470 HOMER STREET (COMPLETE APPLICATION)
DP-2021-00952 - DD

DEVELOPMENT PERMIT STAFF COMMITTEE MEMBERS

DEVELOPMENT PERMIT STAFF COMMITTEE RECOMMENDATION: APPROVE

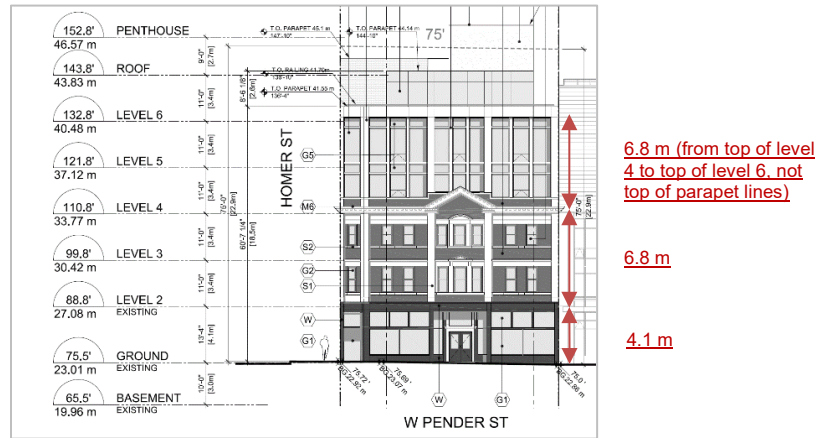
- ii. reducing the visual prominence of the proposed extruded metal frames, with particular attention given to those aligned with the existing stone pilasters of the heritage façades; and

Note to Applicant: The proposed repetitive pattern of the extruded metal frames create a disproportionate massing that reads as dominant, instead of subordinate, to the historic façades. Further, the design rationale notes that the new addition is proportionally equal to the existing heritage building, however staff note that the height is based on the lowest elevation along Homer Street, instead of the principal façade along West Pender Street, resulting into a heavier form (refer to detail from architectural drawing sheet A401, with mark-up added by staff below).

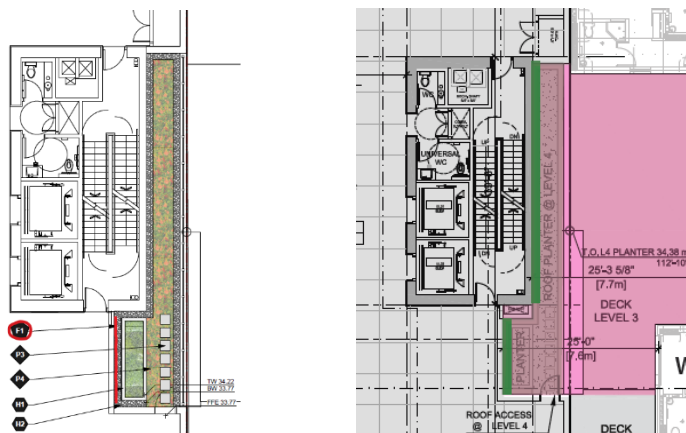
- A.1.14 provision of detail drawings to accurately show typical conditions, including interface between the heritage façade and the contemporary addition, including annotations consistent with work as outlined in the *Conservation Plan*;

- Note to Applicant:** Typical detail drawings should supplement the preliminary wall section drawing 1/A801, confirming that adequate assessment and recording of existing conditions have been conducted to verify scope and feasibility of conservation work proposed.
